EPC STORMWATER REVIEW COMMENTS ARE
SHOWN IN ORANGE BOXES WITH BLACK TEXT

PRELIMINARY DRAINAGE REPORT FOR BRADLEY POINT FILING NO. 1

EL PASO COUNTY, COLORADO

PCD-ENGINEERING REVIEW COMMENTS
IN BLUE BOXES WITH BLUE TEXT

BRADLEY POINT FILING NO. 1 - EXISTING DRAINAGE MAP

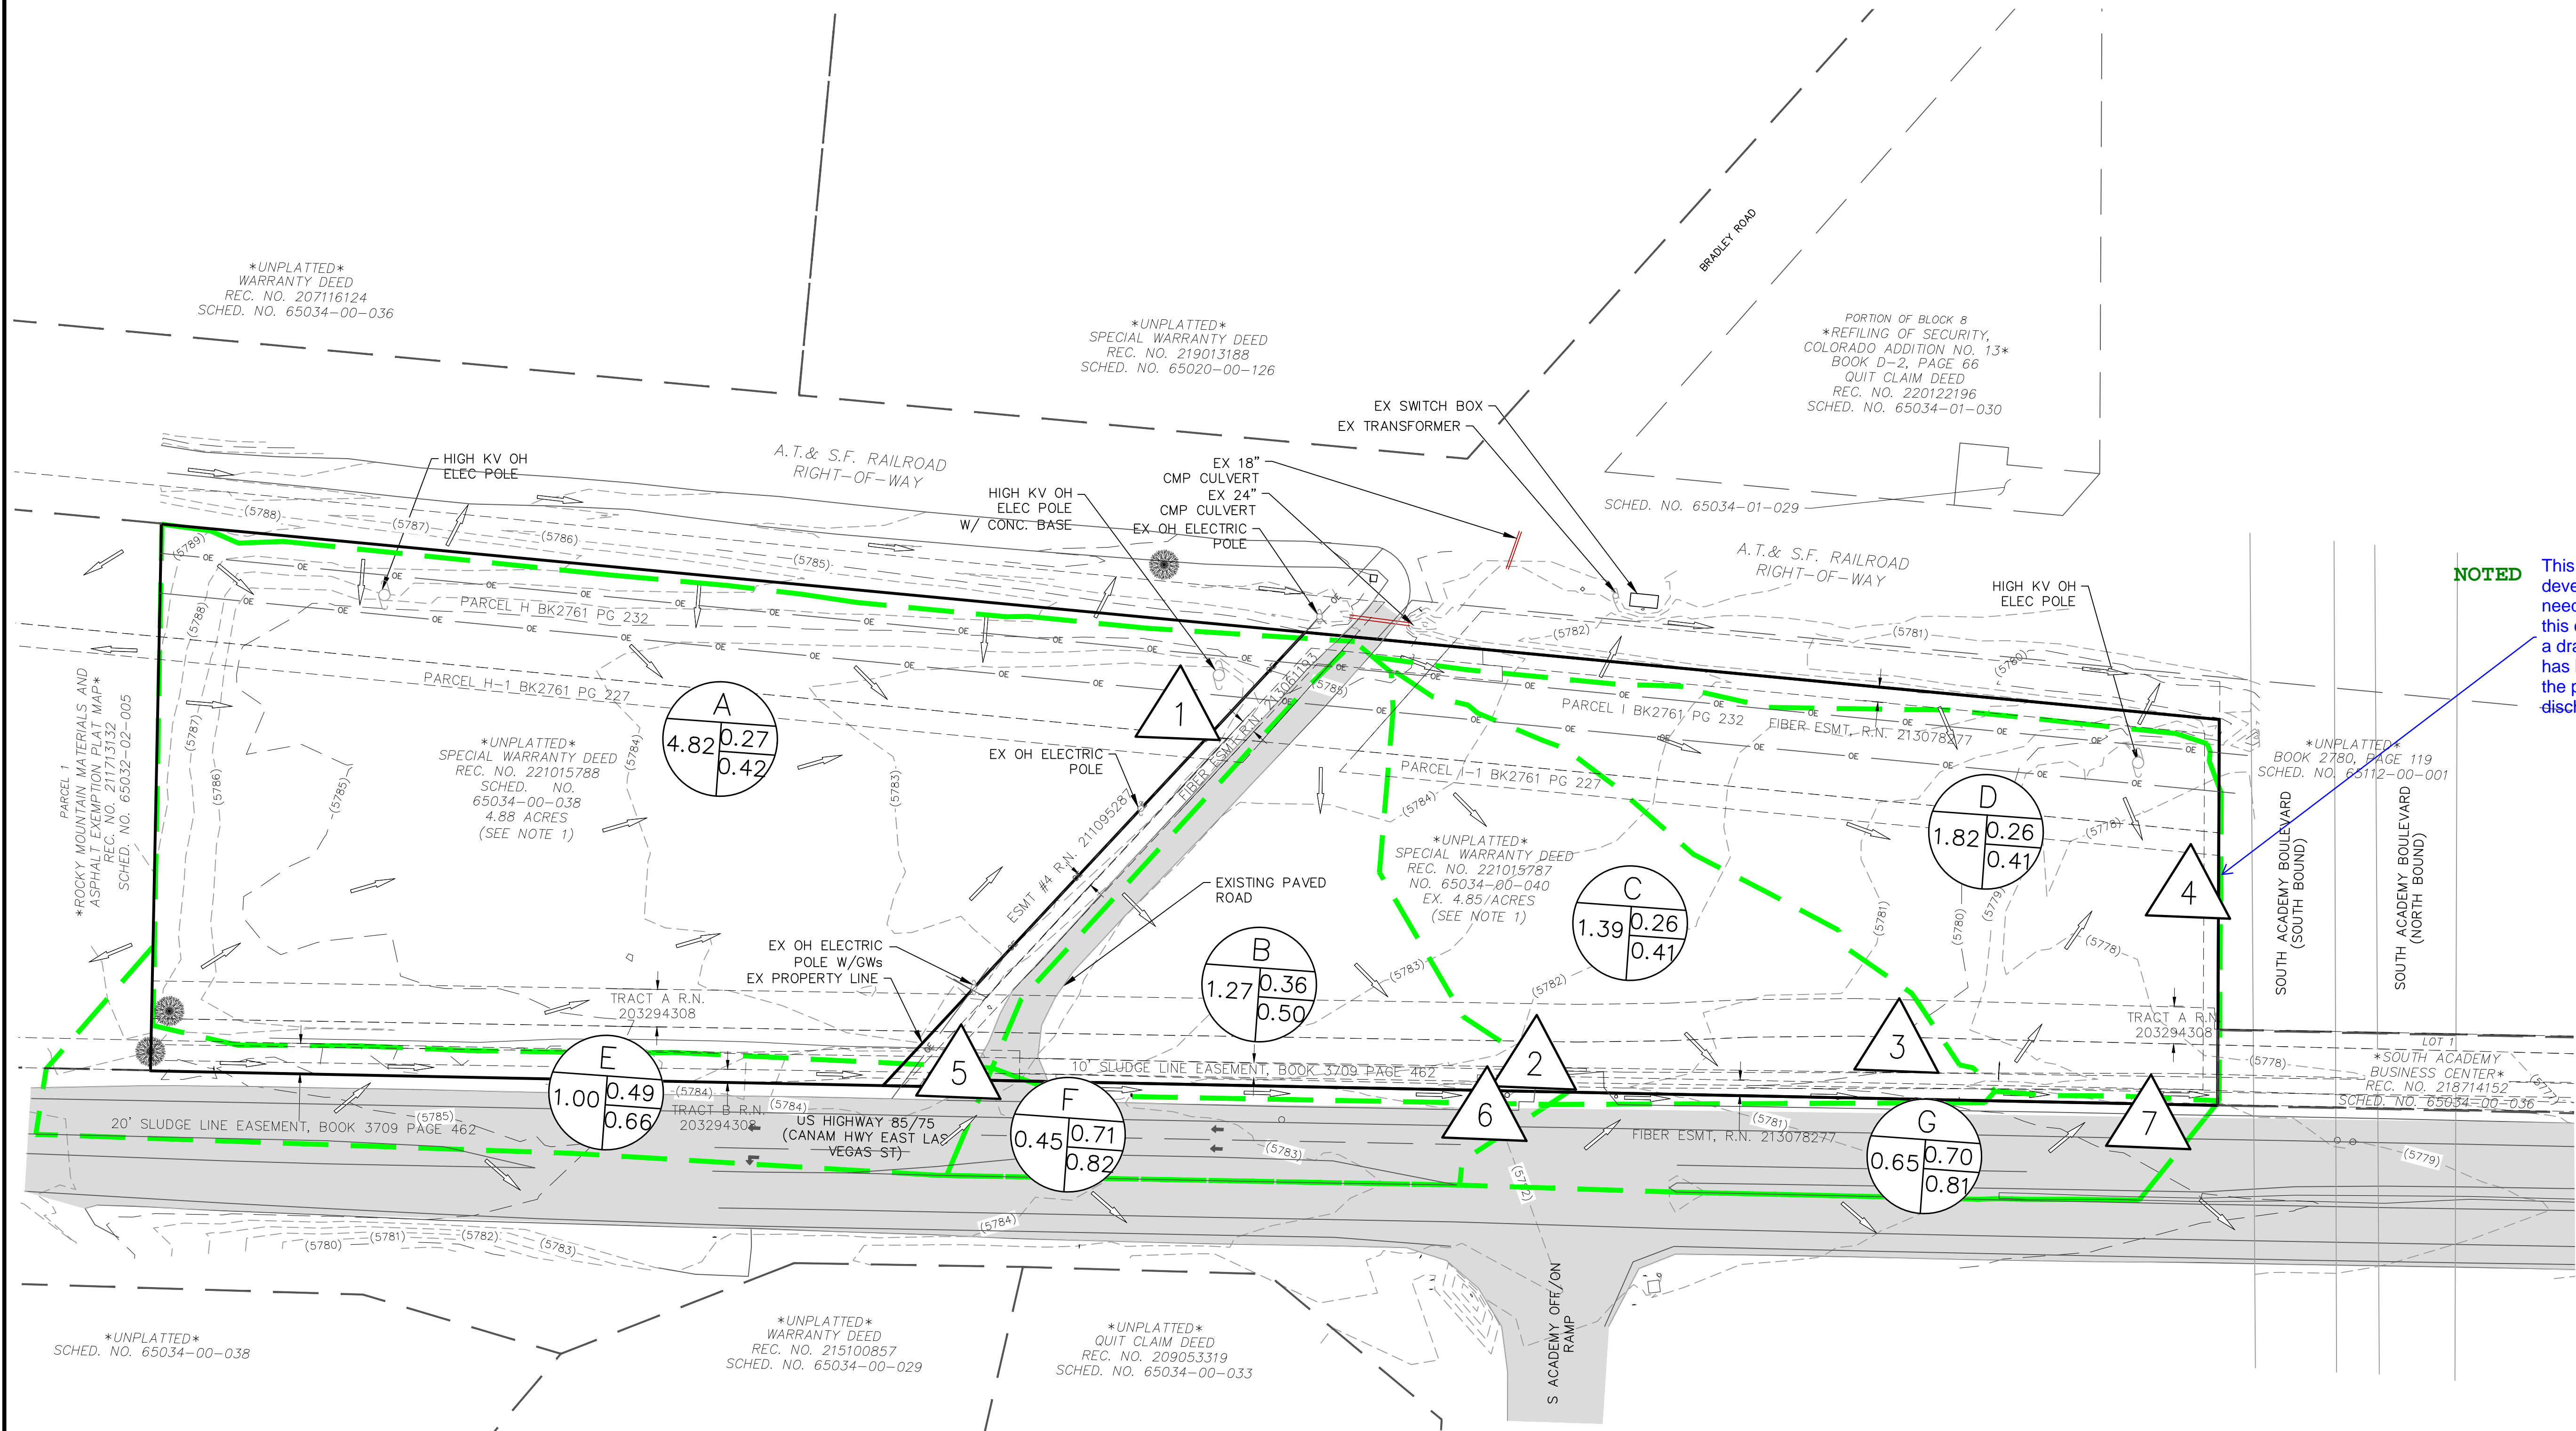
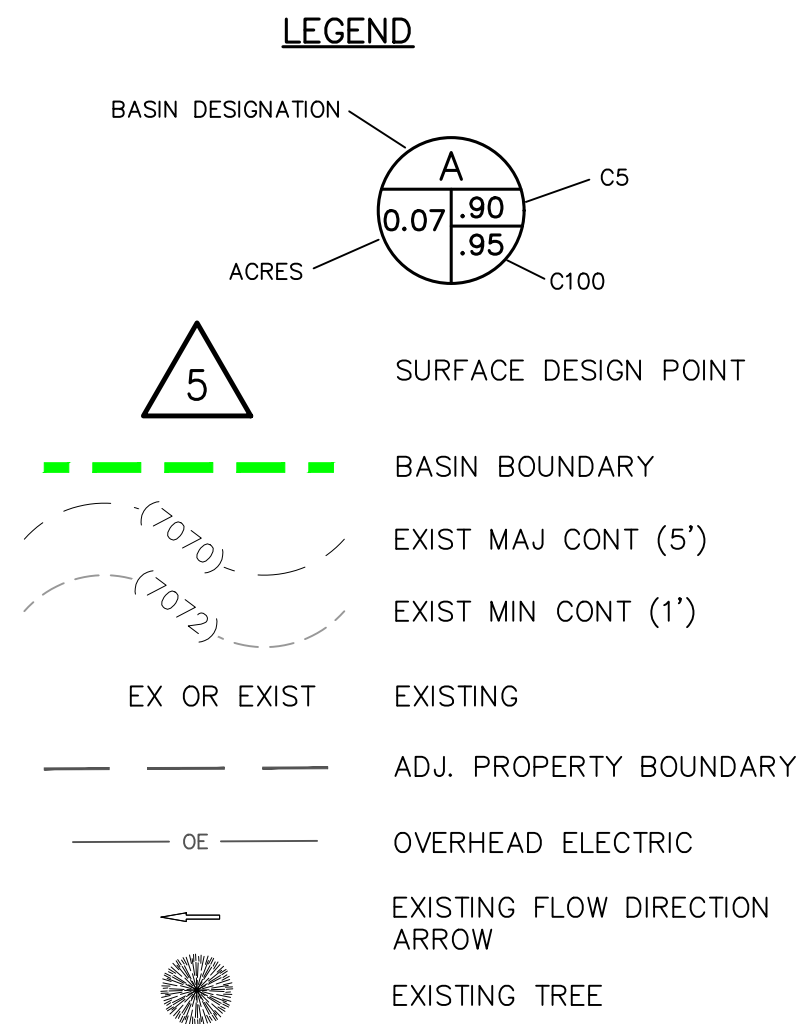
Provide roadside ditch and downstream conveyance calculations.

NOTED This is a wide swale - developed release needs to approximate this condition unless a drainage easement has been obtained for the proposed point discharge.

NOTED REVISED IN TEXT
Does the ditch have capacity or do flows enter the site?

NOTED REVISED IN TEXT, EXHIBIT INCLUDED

BRADLEY POINT FILING NO. 1 - PROPOSED DRAINAGE MAP

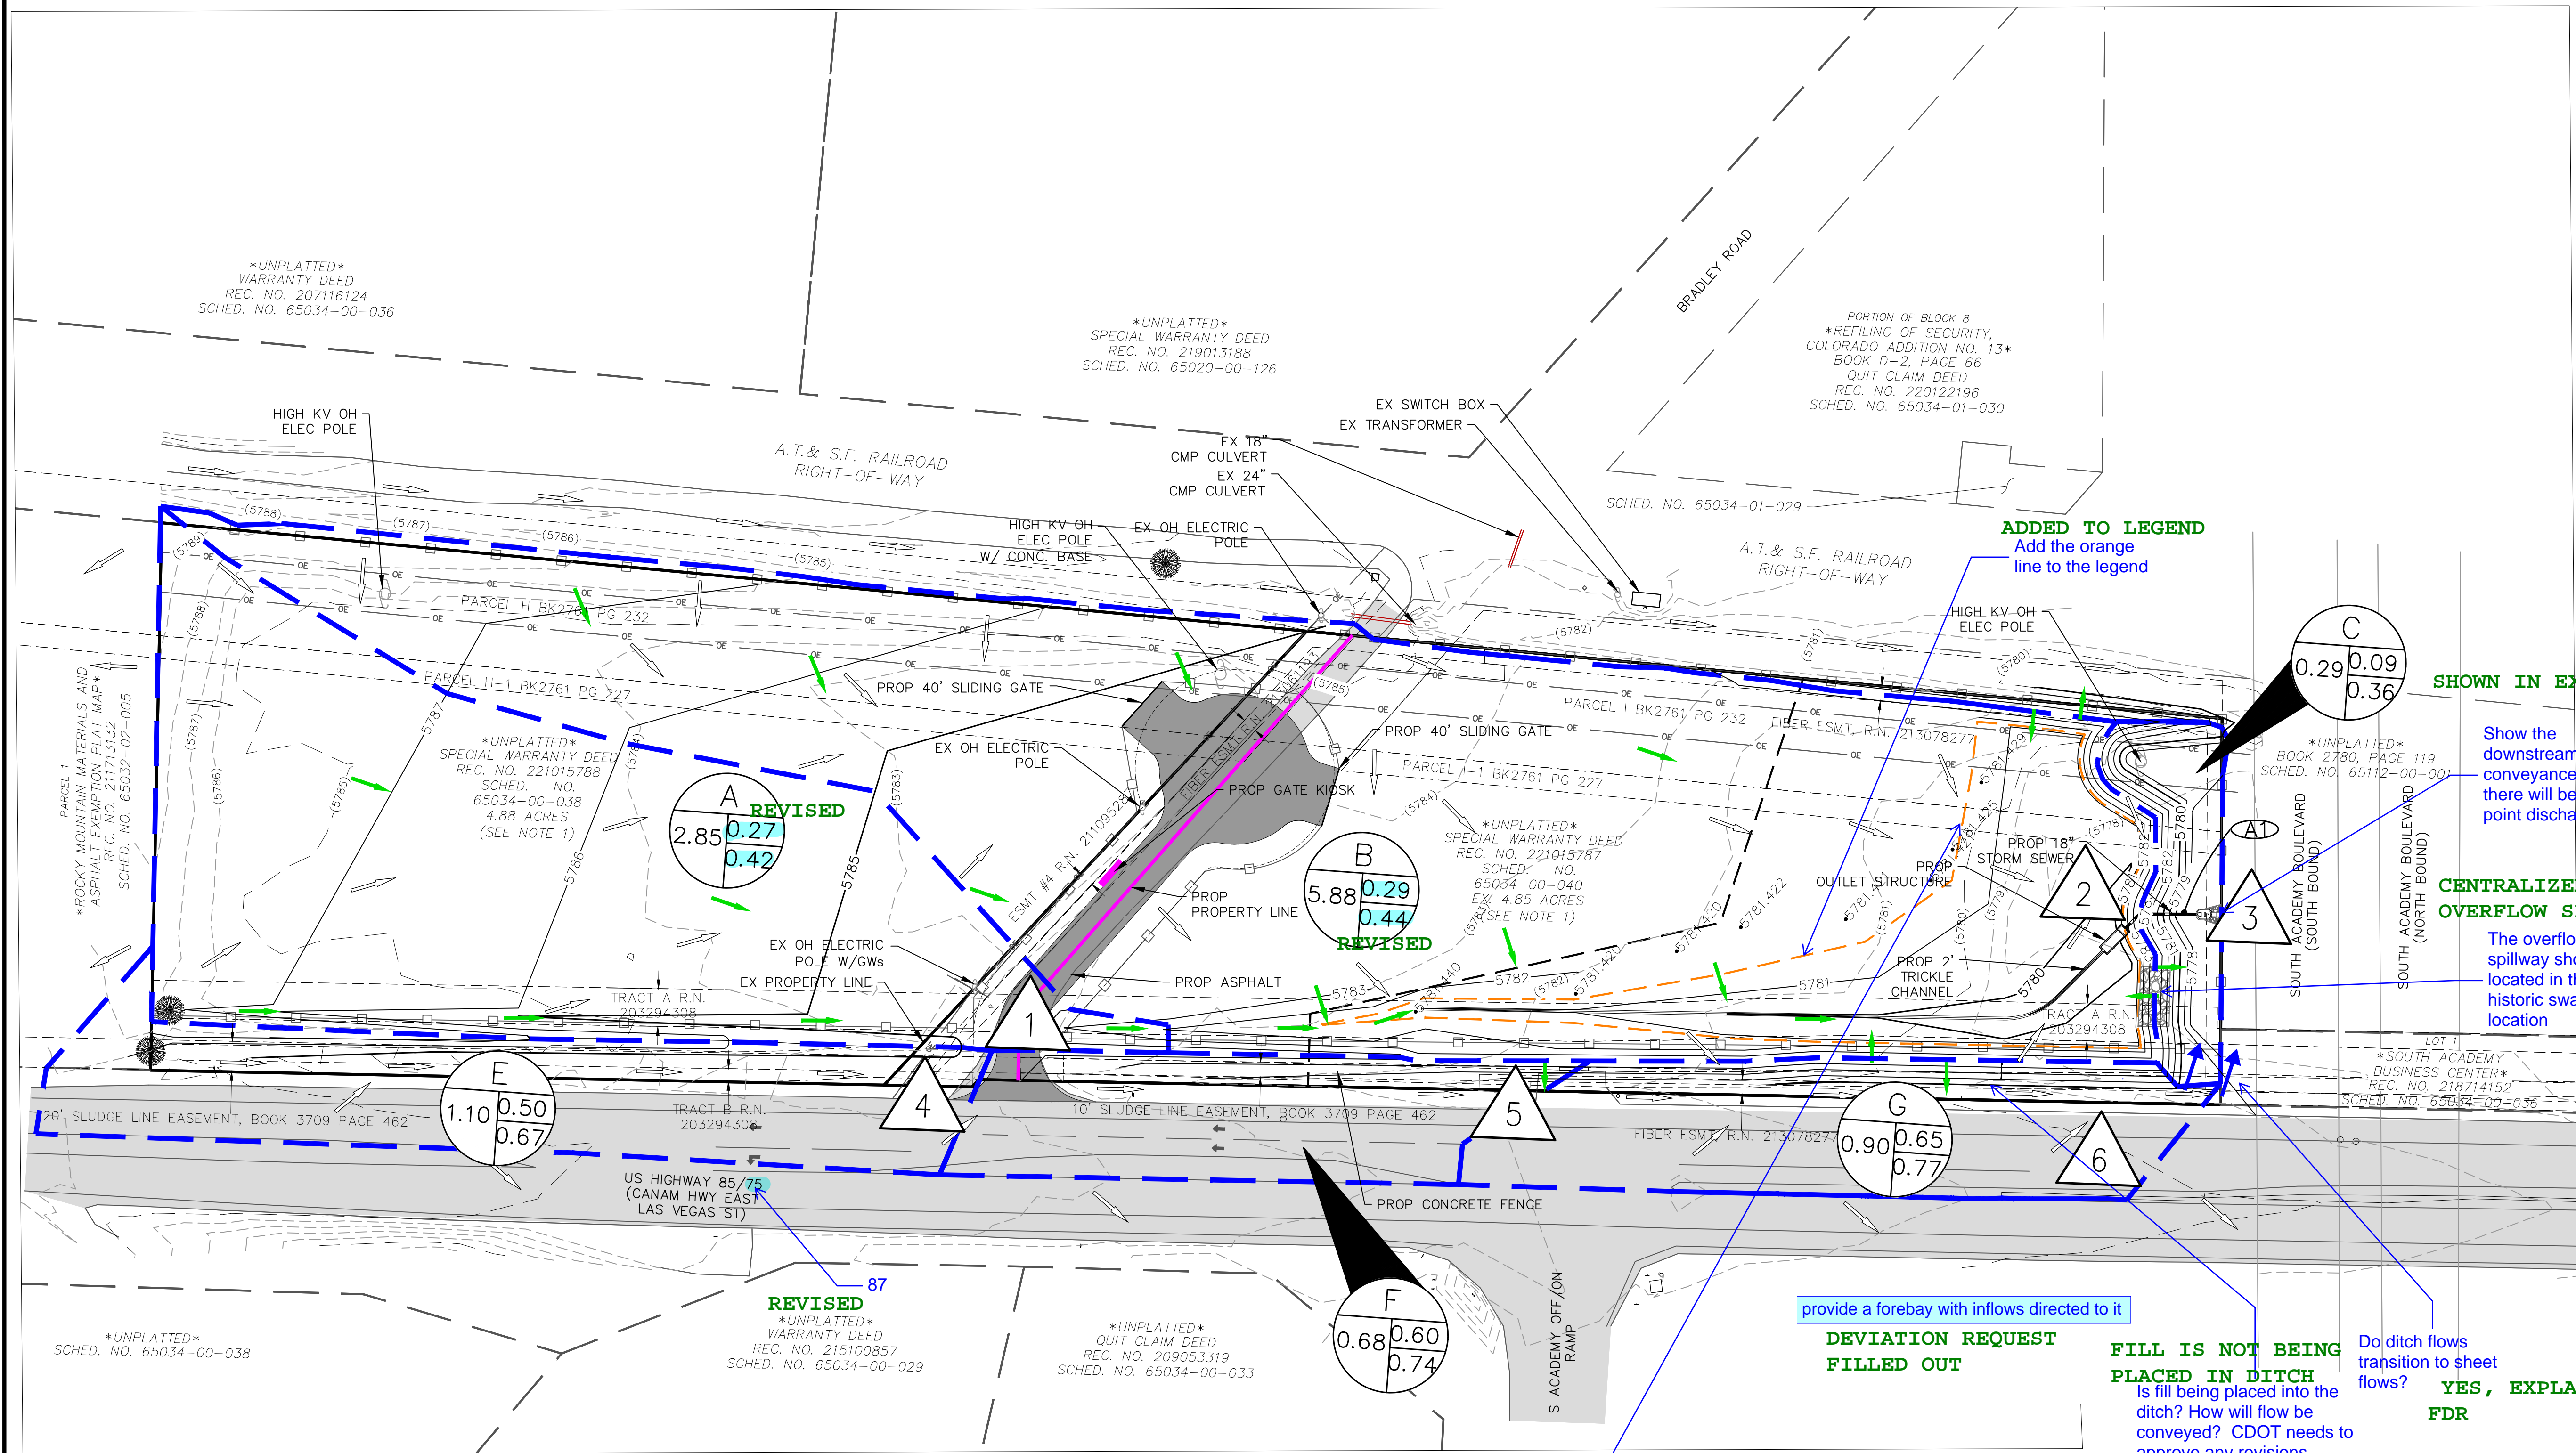
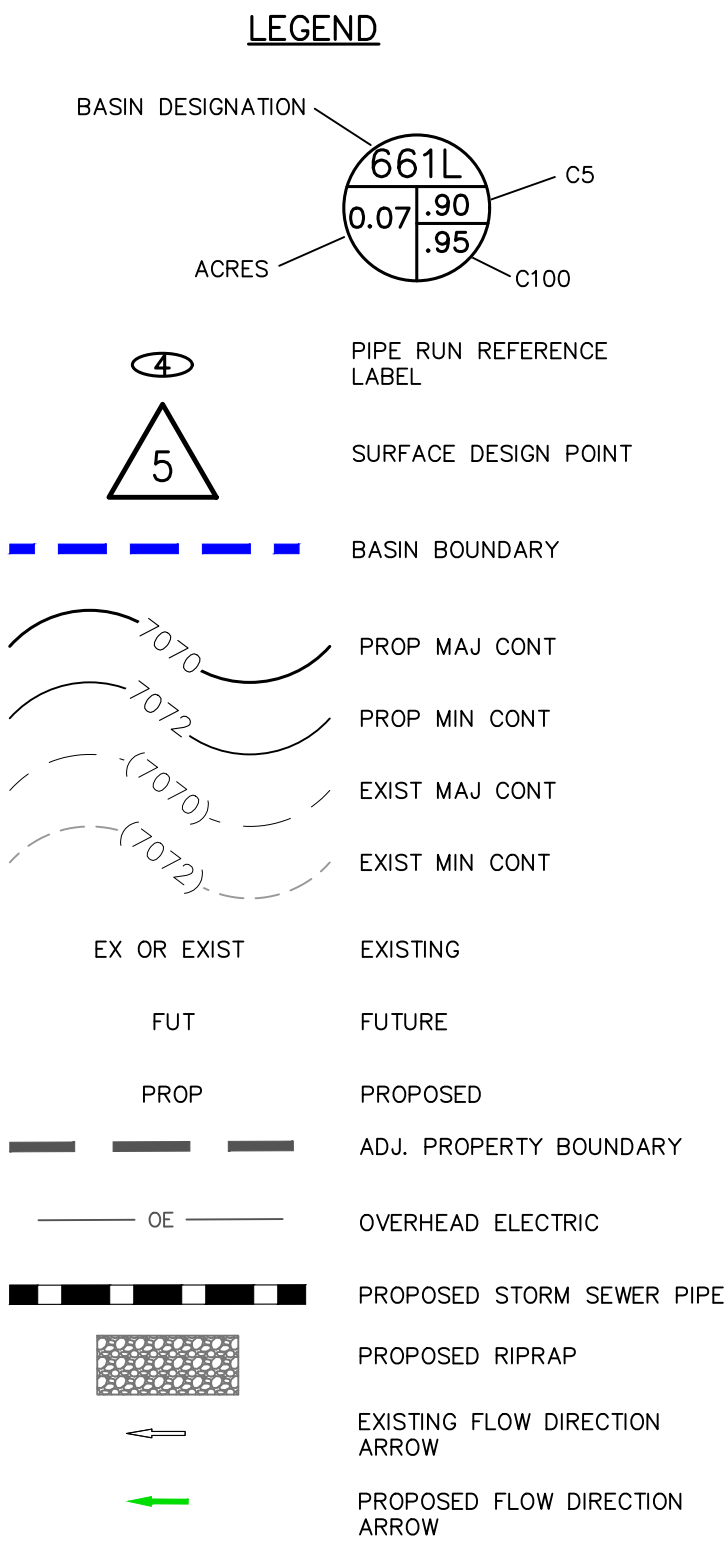
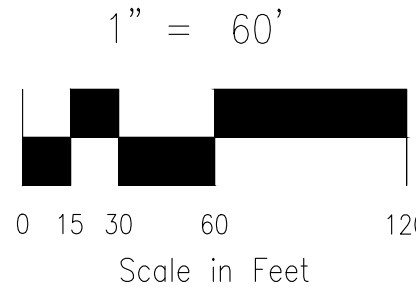
How will the storage area be separated from the ponding area?

provide a forebay with inflows directed to it
DEVIATION REQUEST FILLED OUT

FILL IS NOT BEING PLACED IN DITCH
Is fill being placed into the ditch? How will flow be conveyed? CDOT needs to approve any revisions.

Do ditch flows transition to sheet flows? **YES, EXPLAINED IN FDR**

Provide roadside ditch cross-sections at DP 5 and DP 6 and capacity calculations

SIGN LOCATIONS WILL BE PROVIDED

ROADSIDE DITCH CROSS SECTIONS PROVIDED
